CITY OF ALBUQUERQUE

Re: Coors Plaza SW repais
3200 Coors Blvd NW
Traffic Circulation Layout
Engineer's/Architect's Stamp 08/14/2019 (G11D006)

Based upon the information provided in your submittal received 08-15-2019, the above referenced plan cannot be approved for Building Permit until the following comments are addressed:

Sheet Title: Traffic Circulation Layout

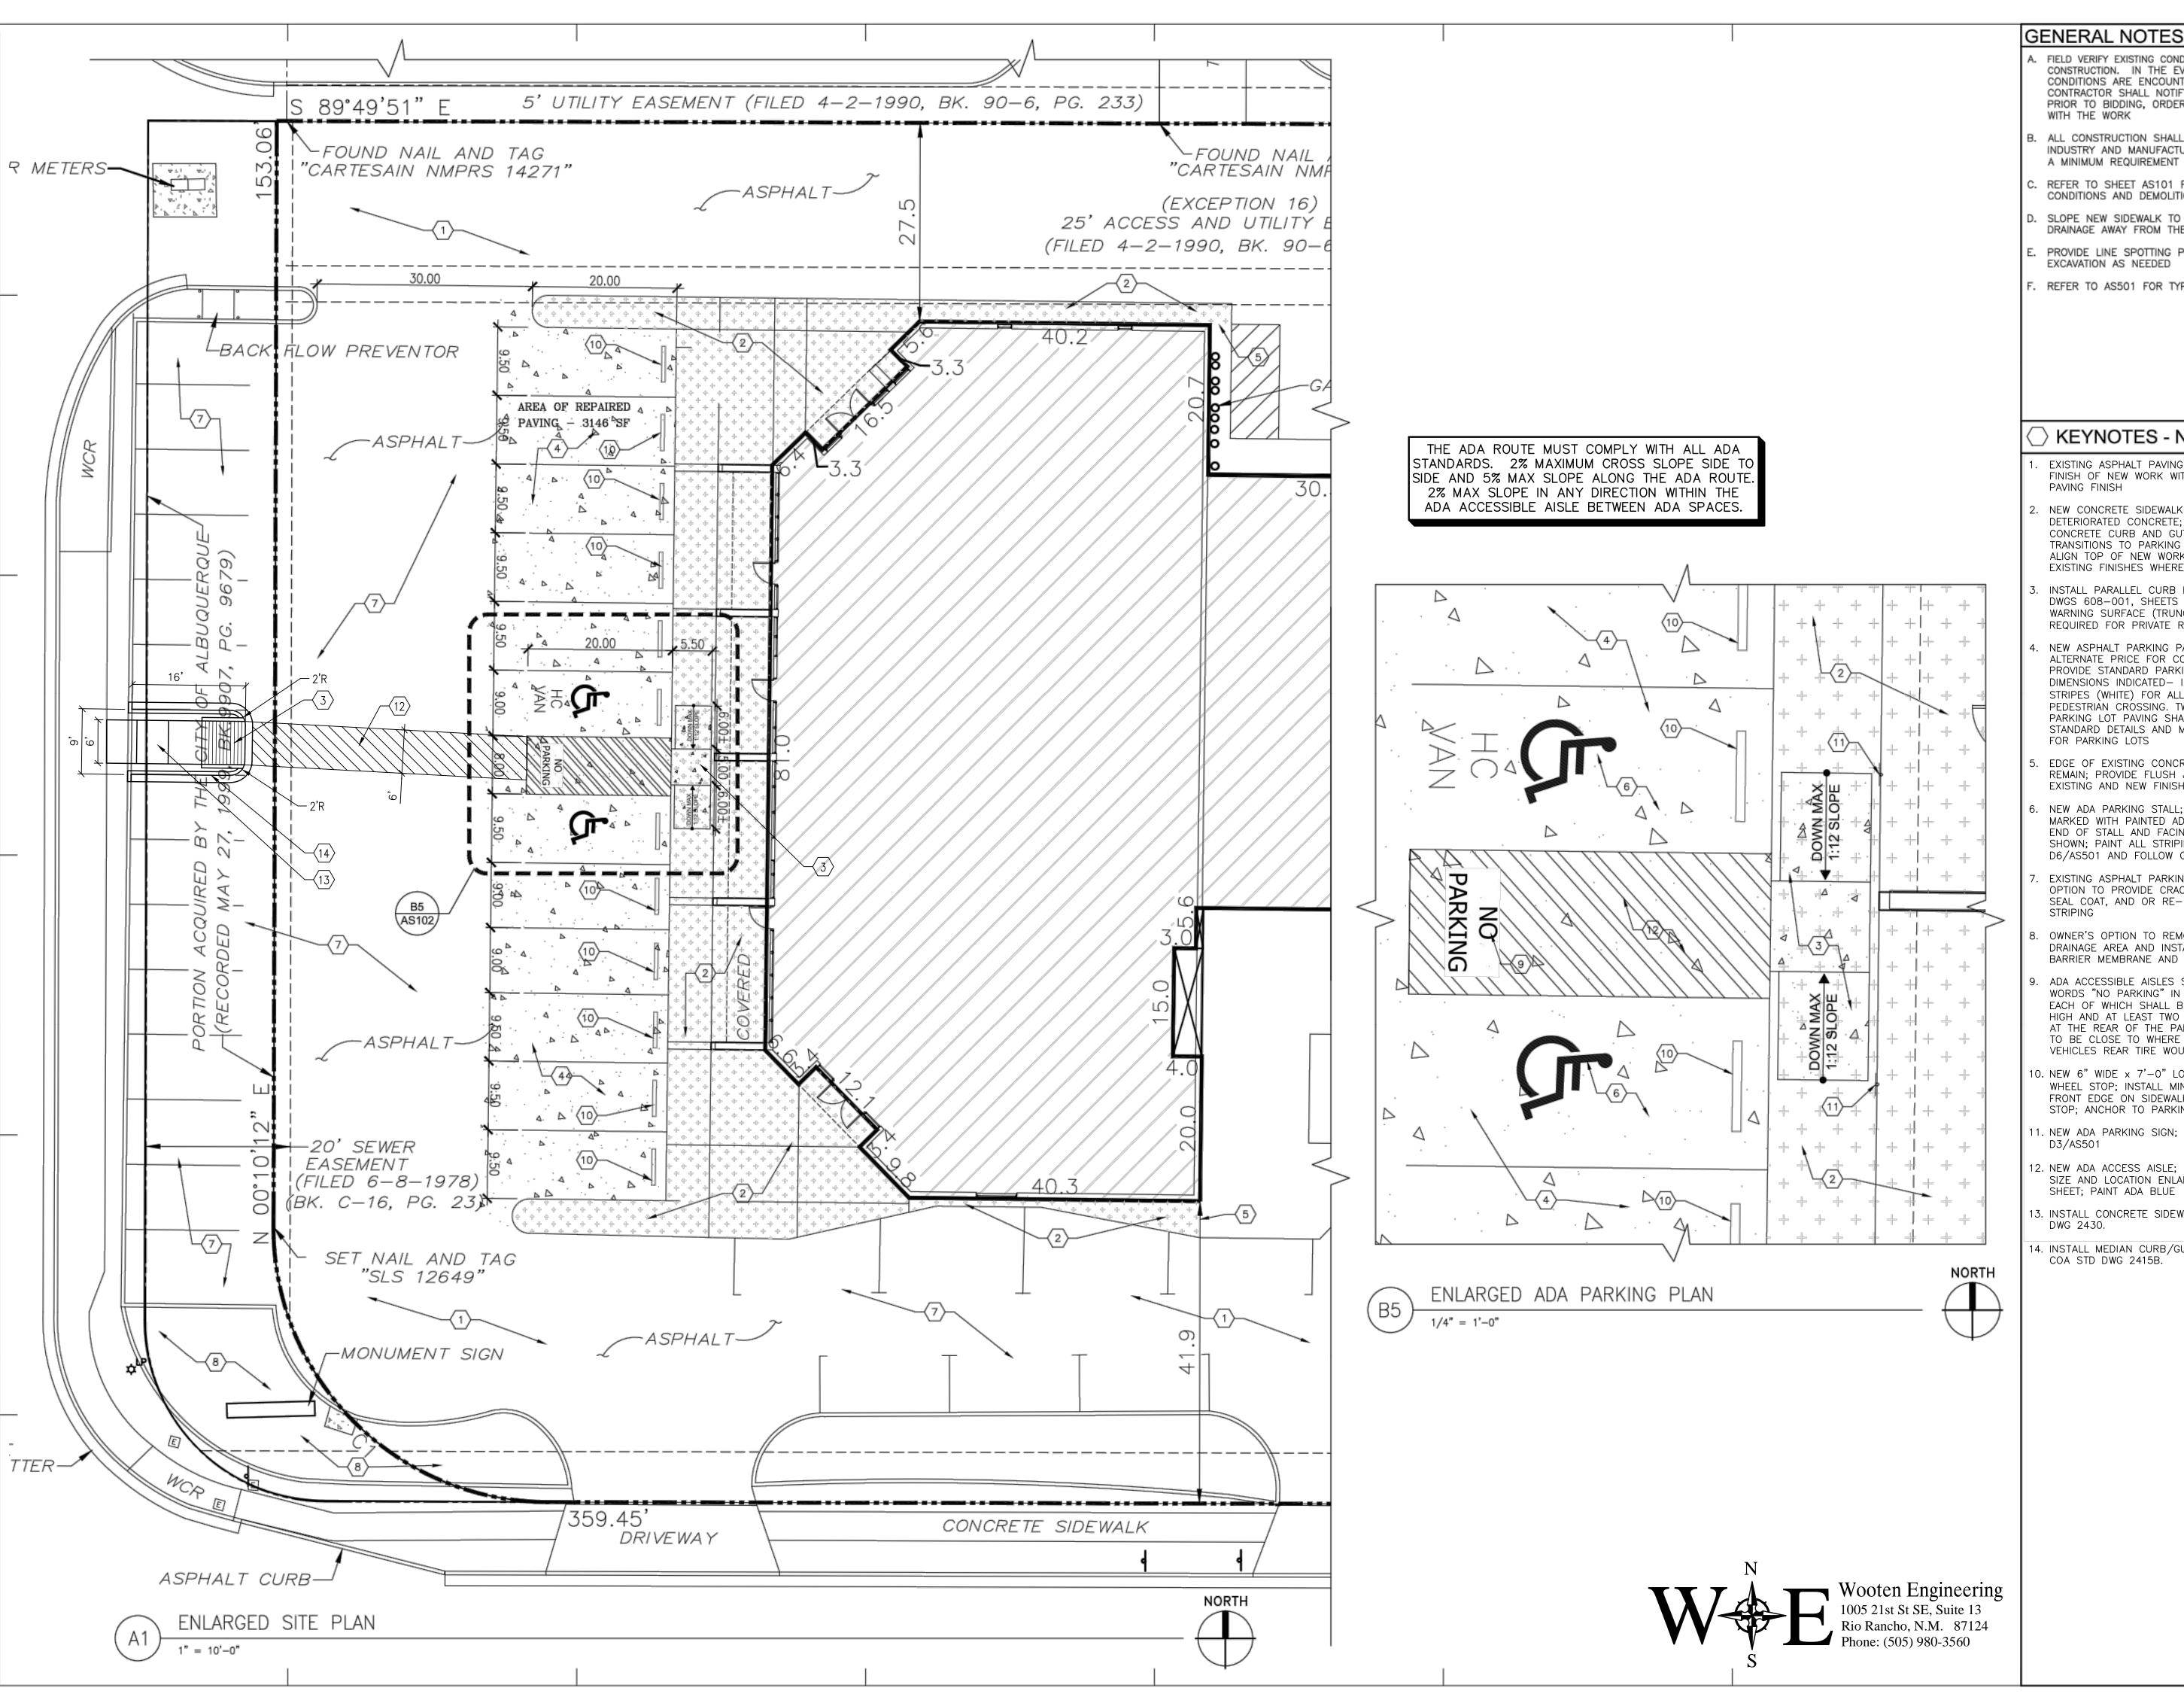
- 1. Please show a vicinity map showing the location of the development in relation to streets and well known landmarks.
- 2. List the number of parking spaces required by the zoning code as well as the proposed number of parking spaces including **bicycle and motorcycle parking.**

- 3. The ADA accessible parking sign must have the required language per 66-7-352.4C NMSA 1978 "Violators Are Subject to a Fine and/or Towing." Please call out detail and location of signs.

- 4. Motorcycle parking spaces shall be designated by its own conspicuously posted upright sign, either free-standing or wall mounted per the zoning code.

- 5. All bicycle racks shall be designed according to the following guidelines:
 - a. The rack shall be a minimum 30 inches tall and 18 inches wide.
 - b. The bicycle frame shall be supported horizontally at two or more places. Comb/toaster racks are not allowed.

- c. The rack shall be designed to support the bicycle in an upright position. See the IDO for additional information.
 - d. The rack allows varying bicycle frame sizes and styles to be attached.

- e. The user is not required to lift the bicycle onto the bicycle rack.
 - f. Each bicycle parking space is accessible without moving another bicycle.

- 6. Bicycle racks shall be sturdy and anchored to a concrete pad.
- 7. A 1-foot clear zone around the bicycle parking stall shall be provided.
- 8. Bicycle parking spaces shall be at least 6 feet long and 2 feet wide.

9. Refuse vehicle maneuvering shall be contained on-site. The refuse vehicle shall not back into the public right of way.; provide a copy of refuse approval.
